ADDENDUM

PLANNED DEVELOPMENT AMENDMENT - JULY 31, 2023

Applicant, Baker Creek 2, LLC submits the following Addendum to it's Planned Development Amendment Application of July 31, 2023.

Baker Creek North Site - McMinnville, OR

BUILDING 5 - EAST ELEVATION

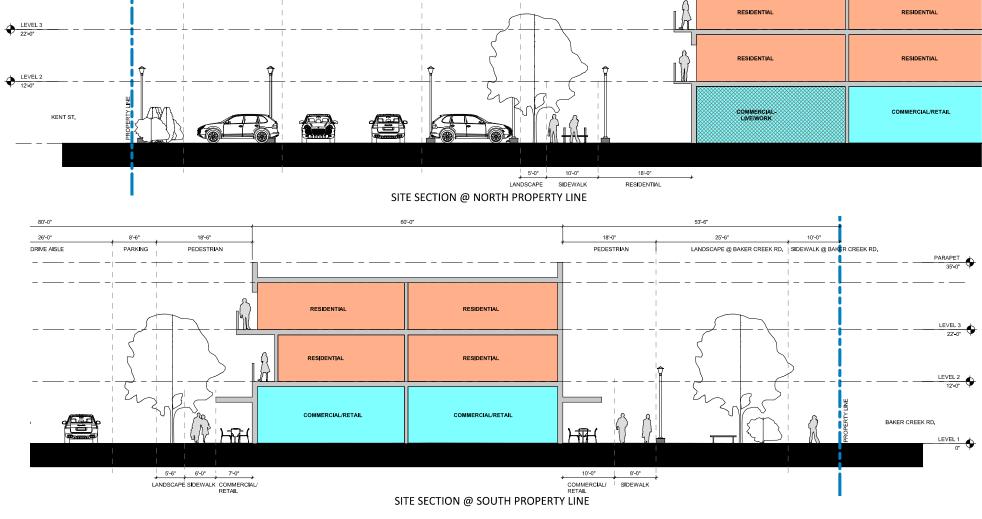
- 1. Applicant removes pages 18 and 19 from Attachment 2 the Site Plan. These pages are the sheets setting forth the proposed design of buildings 5, 6 and 7, the 3-story apartment buildings. These Pages will be replaced with pages 22 and 23.
- 2. In addition, we are adding pages 9, 10, 11 and 12 to the Site Plan to illustrate some of the elevations of the proposed buildings. (The total number of pages in the Site Plan is now 23 instead of 19.)
- 3. Applicant requests to amend Condition of Approval #5(c) to allow maximum roof height of 45 without a step back for the gabled roofs of buildings 5, 6 and 7 and for the "towers" of buildings 1 and 2. In addition to allow parapet heights of up to 40 feet on the mixed use buildings no.s 1, 2, 3 and 4.

As explained throughout the Planned Development Amendment Application of July 31, 2023 allowing 45 feet maximum height without step back allows this project to have the three story apartment buildings in buildings 5, 6 and 7 with pitched roofs. The eves for these three buildings will still be under 35 feet. This allows a differentiation between the mixed-use buildings and the residential-only buildings to enhance a village-like feel. The 45 feet heights also allow for the addition of the two architectural "towers" on buildings 1 and 2 to provide a dynamic entrance into the piazza.

c. "... No building shall exceed a height of two-three stories without a variance. If any building is proposed to exceed 35 40 feet, the building shall be designed with a step back in the building wall above 35 40 feet to reduce the visual impact of the height of the building, except buildings with a pitched roof, and two buildings with architectural towers may have a maximum height of 45 feet without a step back in the building wall for those towers."
